Revised CL49 LPI State diagrams and changes to the PCS scrambler.

IEEE 802.3az, Chicago, September 2009

Edits to Clause 49 to replace scrambler reset with scrambler bypass.

Revised CL49 LPI TX State diagram

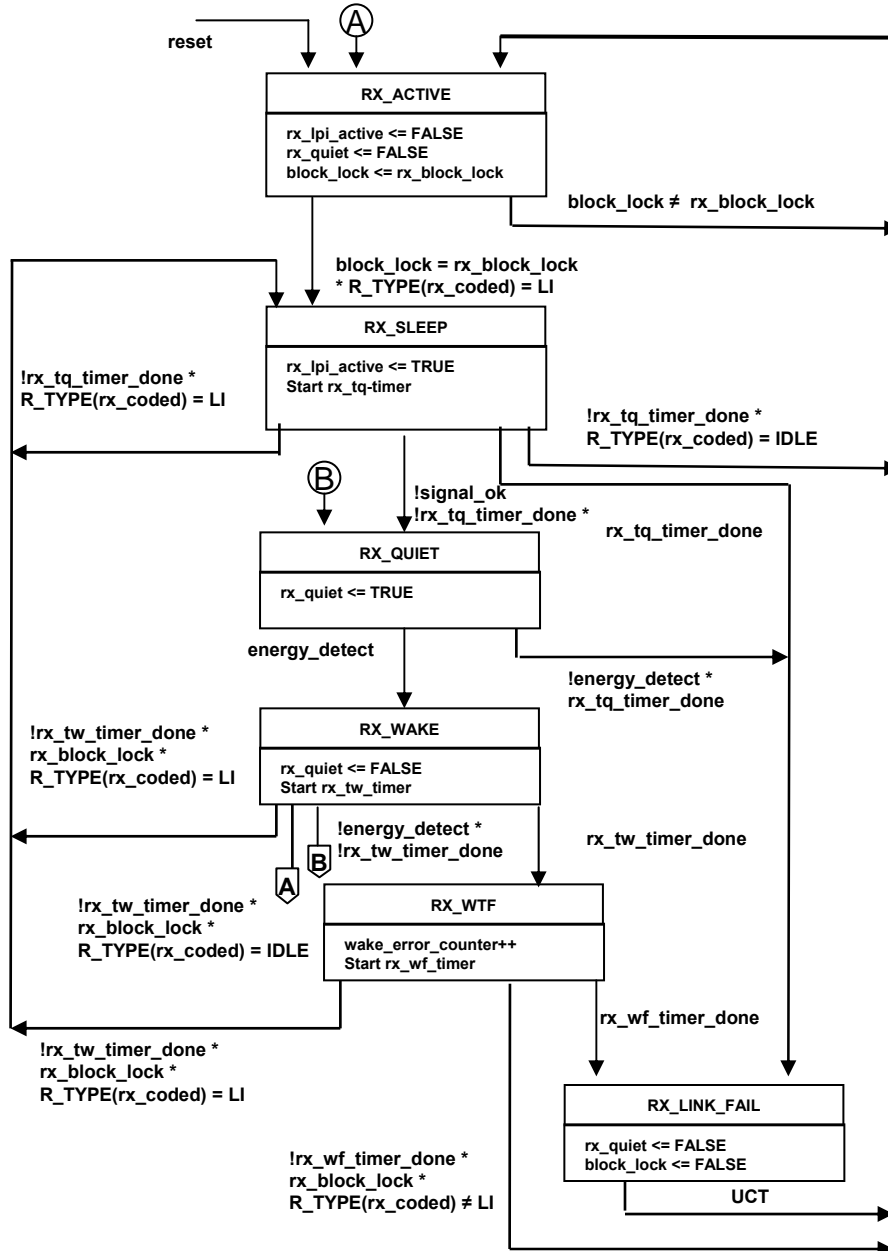
In Figure 49-16

Change “`scrambler_reset`” to “`scrambler_bypass`” in TX_ACTIVE and SCR_RESET states

Change “`scrambler_reset_enable`” to “`scrambler_bypass_enable`” in transitions from TX_WAKE state.

Rename “SCR_RESET” state to “SCR_BYPASS”.

Figure 49-5—Scrambler

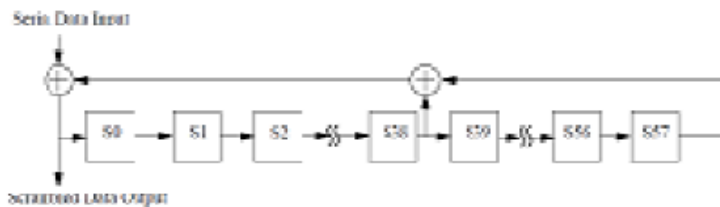
In figure 49-5, show bypass mux at output of scrambler.

Change EEE text after scrambler from...

To aid block synchronization in the receiver when the optional Low Power Idle function is supported, the registers of scrambler shall be held at logic zero while `scrambler_reset` is TRUE.

“To aid block synchronization in the receiver when the optional Low Power Idle function is supported, the scrambler input will bypass the scrambler while `scrambler_bypass` is TRUE.”
